VILLAGE OF MORTON GROVE
APPEARANCE COMMISSION

Tuesday, September 2, 2025 - 7:00 P.M.
AGENDA

Re: Appearance Commission Case AC 25-08
Request for an Appearance Certificate for site, building, landscape plans with associated waivers for a 60-unit mixed-use development proposed under Applications for Special Use and Subdivision (PC 25-07) for the property commonly known as 8500-50 Lehigh Avenue (PIN 10-19-204-020-0000, 10-19-203-021-0000, 10-19-203-022-0000, 10-19-203-023-0000, 10-19-203-025-0000, 10-19-203-013-0000) and a portion of Chestnut Street right of way petitioned for vacation (PC 25-08) in Morton Grove, Illinois. The applicant is 8500 MG, LLC.

Revised site plan (TOP); Outdated site plan in civil drawings (BOTTOM)

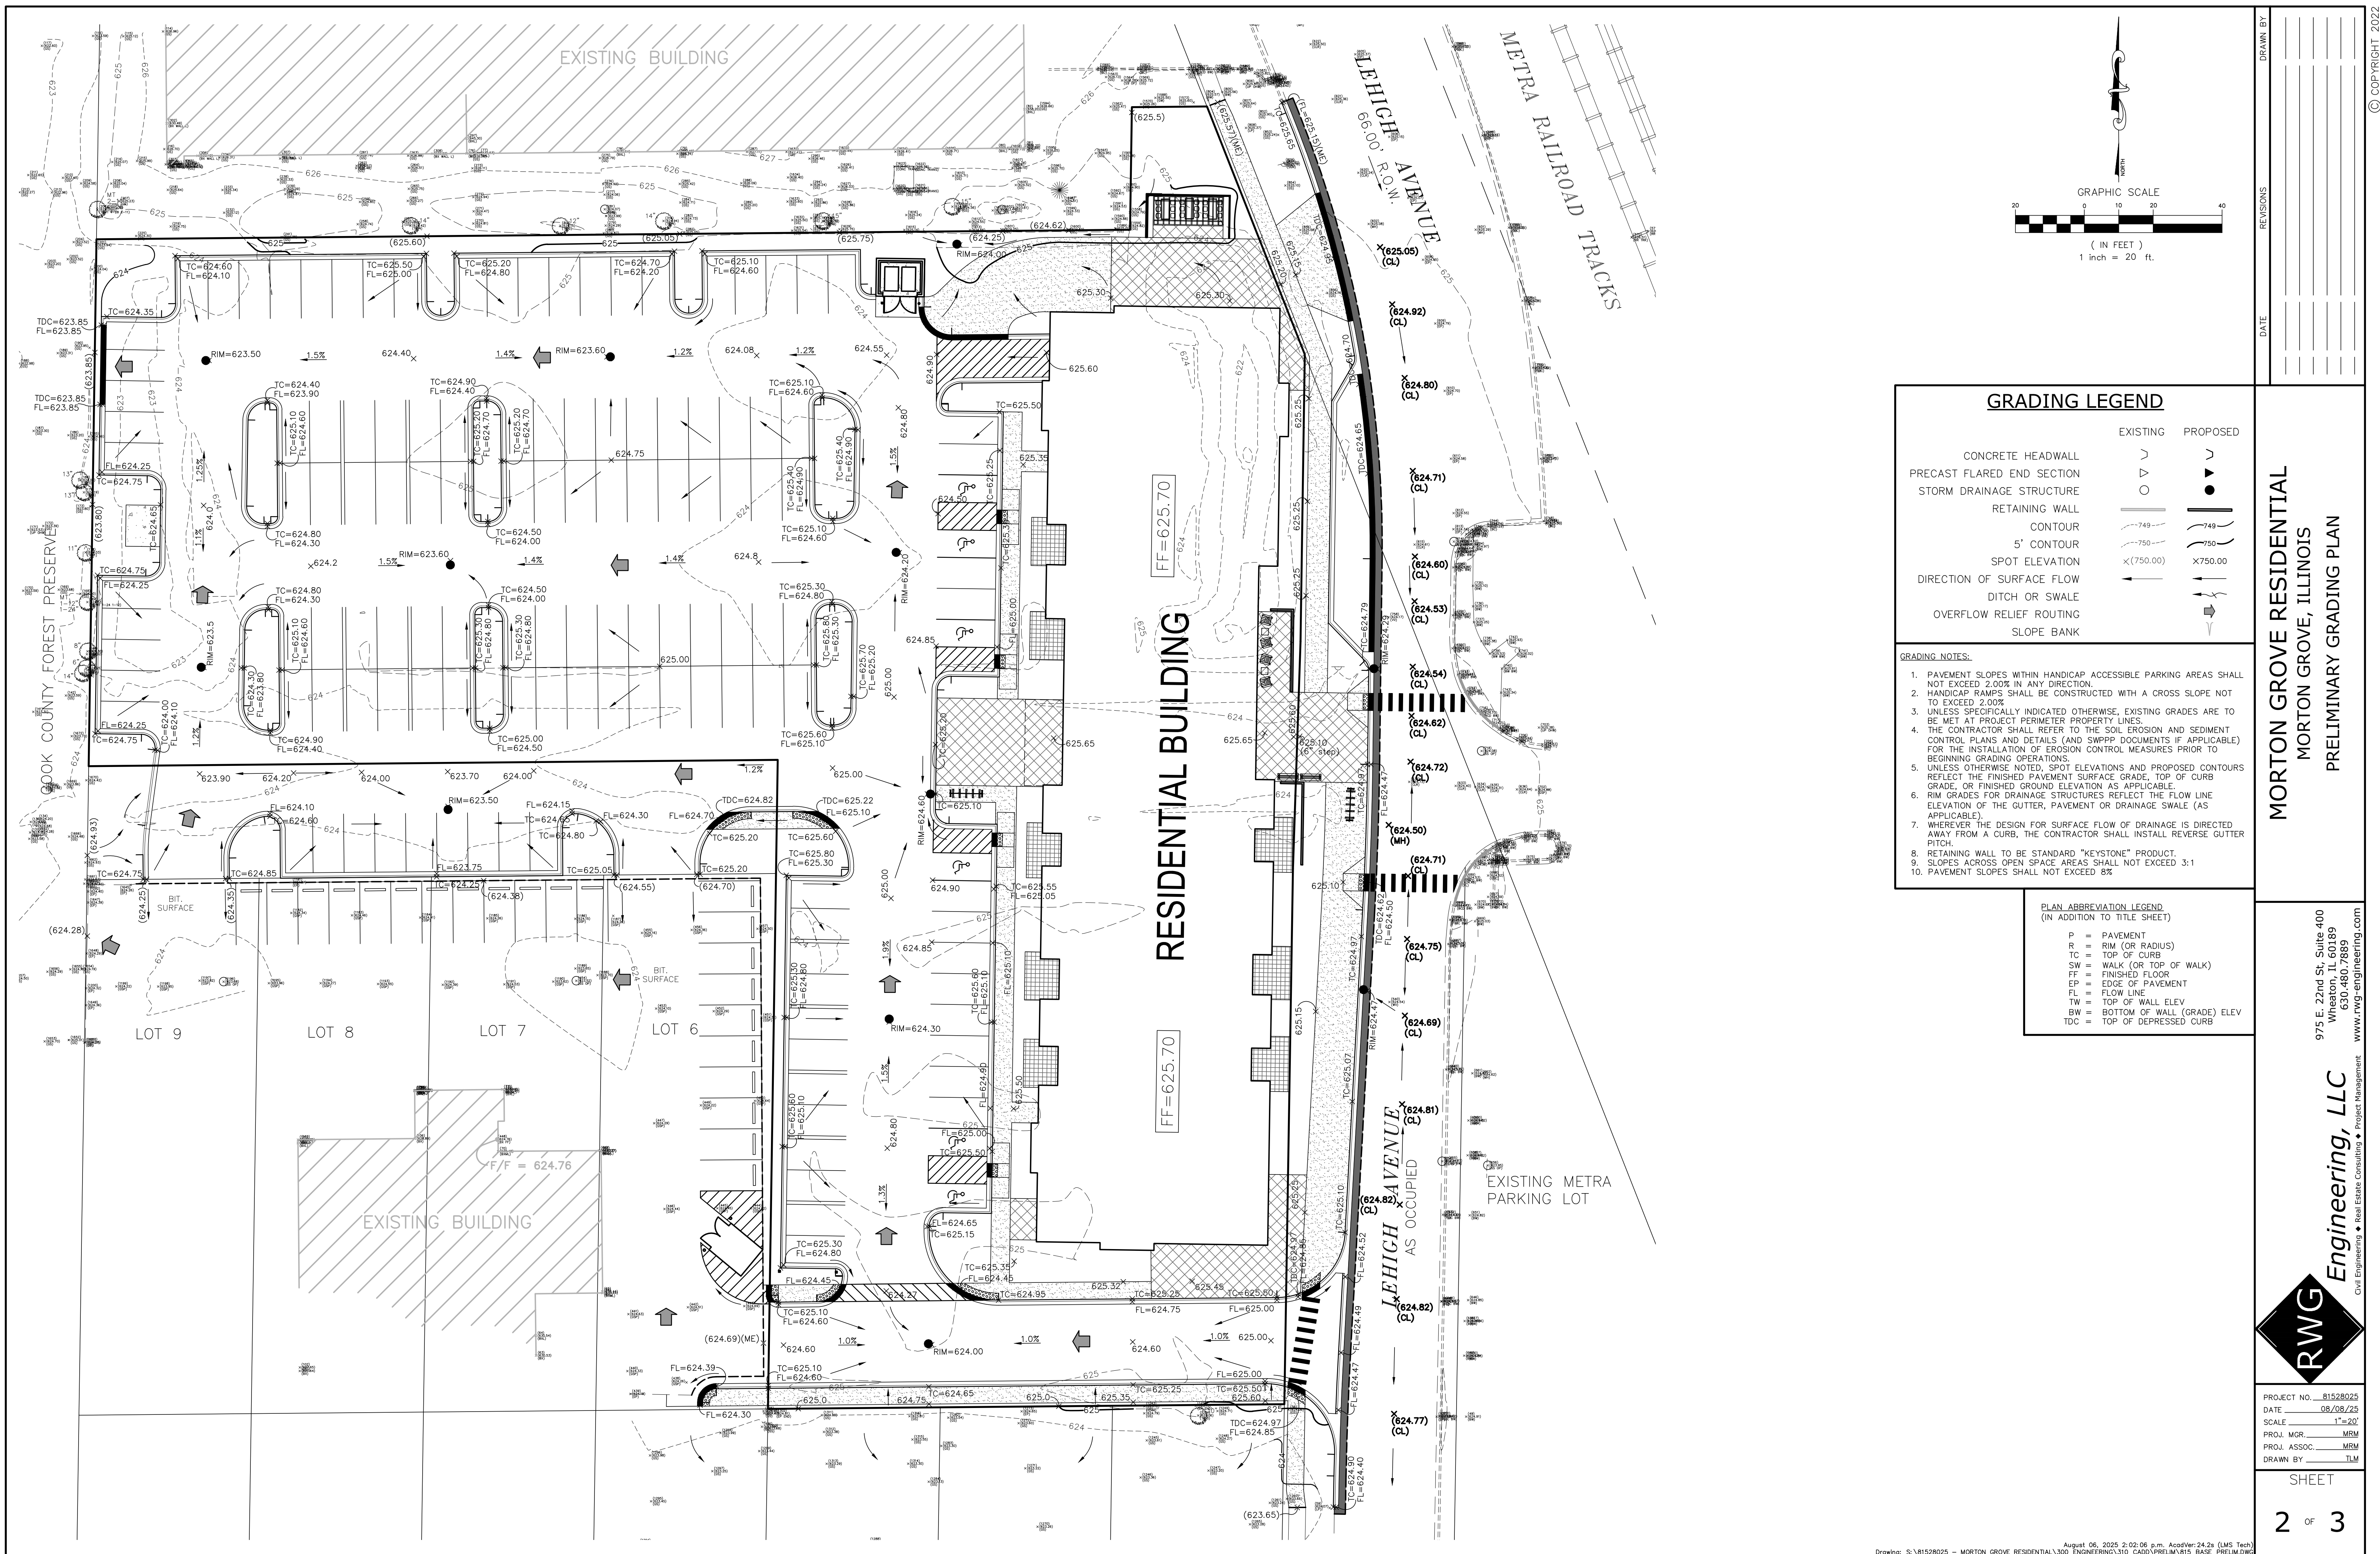
The site plan and landscape plan and related architectural drawings were revised by the applicant to eliminate a retail space and related outdoor seating area at the south end of the building. Staff has request revised civil drawings that replace the previous, outdated building extent and landscaping.
